66319D-05

S E R V I C E N O T E

66319D

Reliability Improvement of Instrument

CORRECT J207 PLACEMENT – alignment to within $< 0.3\text{mm}$

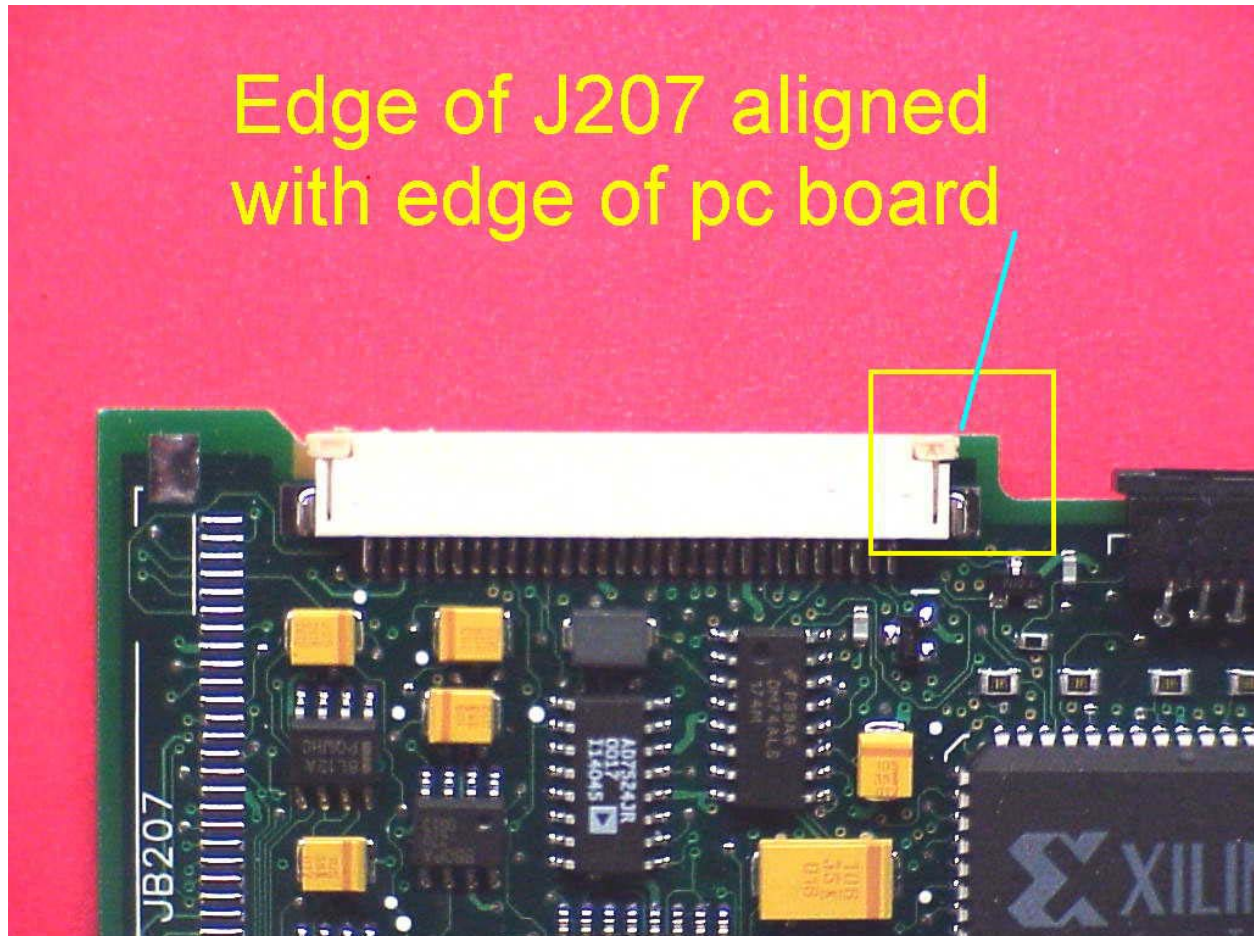
Latent product failure due to misplaced connector J207 on SMT assembly 5064-0018 (GPIB/RS232 interface). Misplacement of J207 could lead to inadvertent contact/shorting of exposed feed-throughs on SMT board. Ultimately, resulting in over-stress of components of damage to SMT board components. Resulting contact could degrade useful life of instrument.

Picture shows connector aligned to edge of SMT board to within $< 0.1\text{mm}$

- 1) Compare placement of J207 to attached photos. Instruments with a “misplaced” J207 should be returned to Agilent for warranty repair.
- 2) Instruments returned to the Service Center for routine calibration should be inspected for this potential defect. Defects should be addressed using Agilent’s unit exchange process with costs being charged to warranty.
- 3) The factory has modified production documentation to include visual inspection and specific electrical testing for this potential short.
- 4) Factory is maintaining feedback to SMT board supplier regarding quality of assembly.
